HISTORIC
FRANKLIN
TENNESSEE

MEMORANDUM

SUBJECT: **Consideration of Resolution 2013-77, A Resolution To Approve the Modified Construction Scope for the 3rd Avenue North Trail/Greenway Project.**

SUBJECT: **Funding Discussion for the 3rd Avenue North Trail/Greenway Project (Bicentennial Park Phase II) (COF Design Contract No. 2012-0069)**

Exhibit B
Page 1 of 2
Overlook at Harpeth River

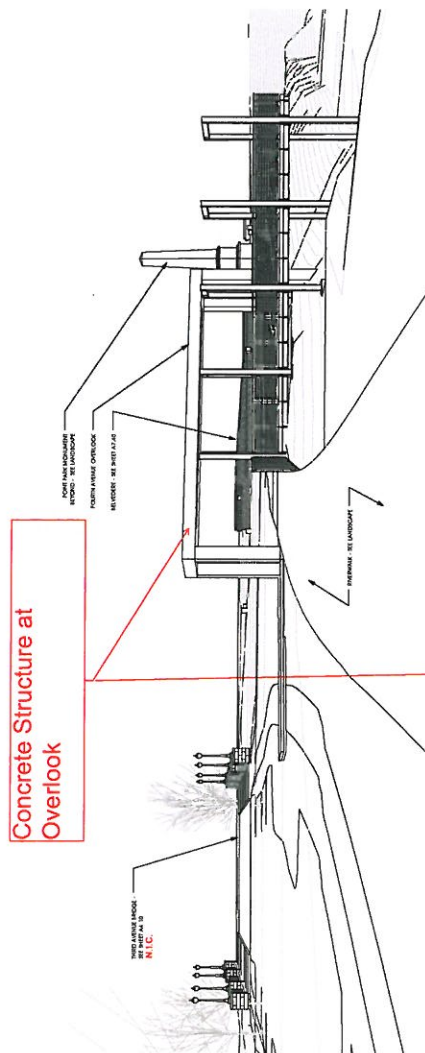
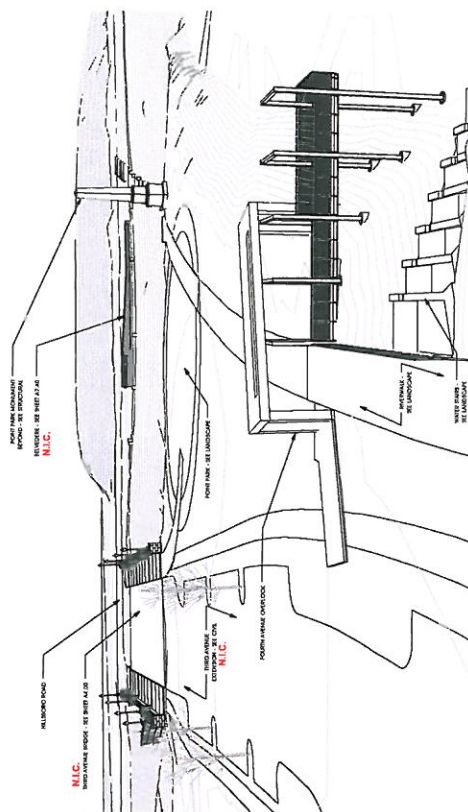
At the CIC meeting, Staff was directed to eliminate the architectural concrete structure at the overlook (\$91,000) and the stone obelisk/monument at Point Park (\$139,000). This results in a cost savings of \$230,000 for the project.

SECTION II: BE IT FURTHER ORDAINED by the Board of Mayor and Aldermen of the City of Franklin, Tennessee, that the following items be eliminated from the current 3rd Avenue North Trial/Greenway Project Scope: the architectural concrete structure at the overlook, obelisk/monument at Point Park, stone pavers at Point Park and one-half the boulders along the top of bank.

Option #2 – Eliminate the Concrete Structure at Overlook (Exhibit B) and the Obelisk at Point Park (Exhibit C). Other items to reduce costs would include changing from stone cut park benches to ornamental steel benches, use cheaper Overlook Railing, change from stone pavers at Obelisk to concrete or sod, and other small reductions. See Exhibit A for a detailed breakdown for possible savings. Small revisions to plans are required. Project cost estimate is around \$1,100,000.00 (\$630,000 Federal / \$470,000 City).

Exhibit C
Page 2 of 2
Obelisk at Point Park

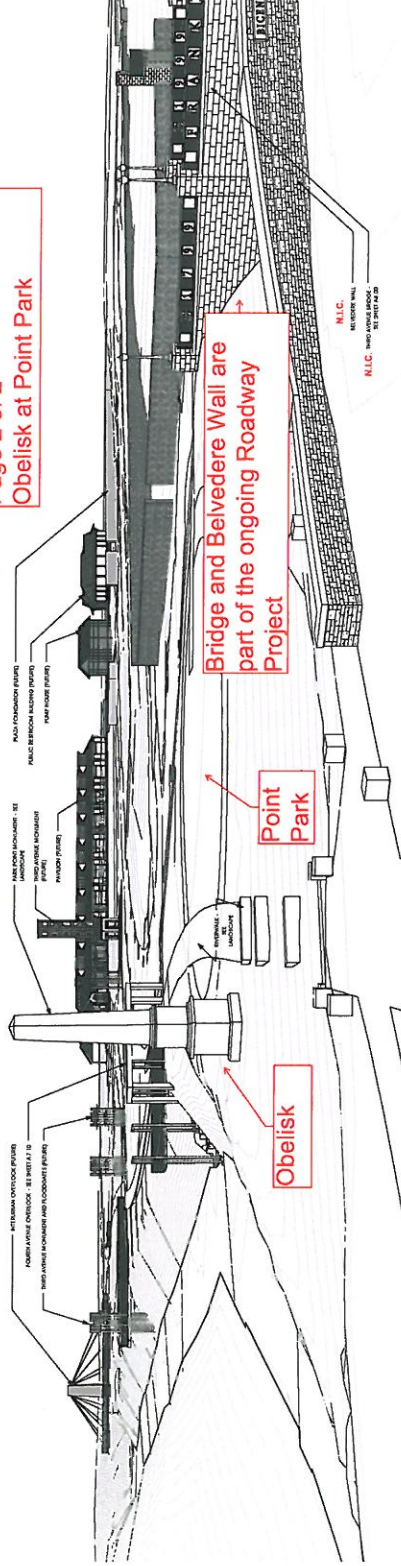
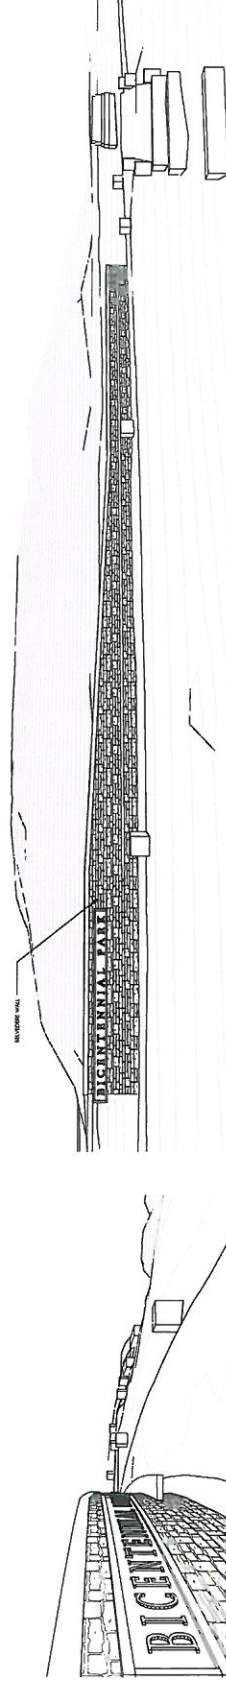
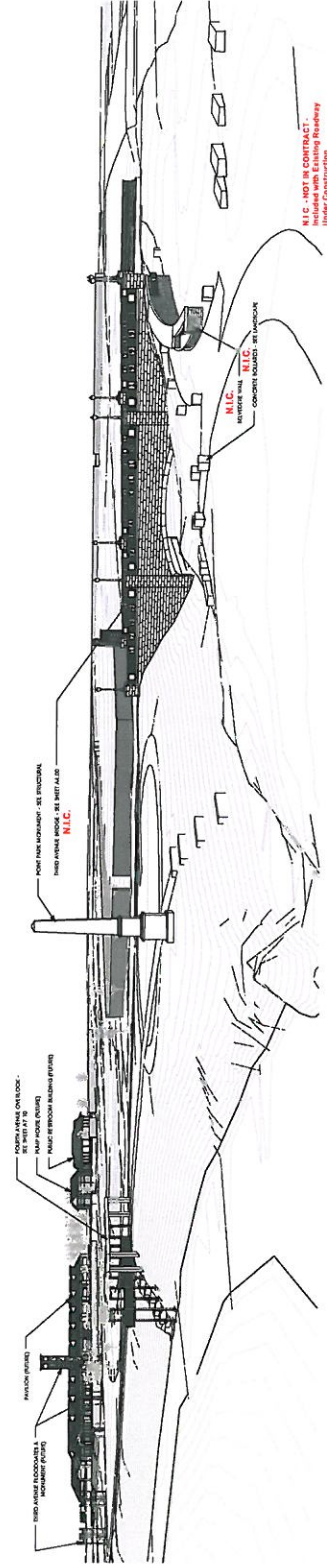
Option #3 – Include all cost savings from Option 2, as well as eliminate Point Park (Exhibit C, Page 2). This will realize another \$140,000 cost reduction. Plans will need revisions, and State permits will need to be resubmitted. Project cost estimate is around \$950,000.00 (\$630,000 Federal / 320,000 City).
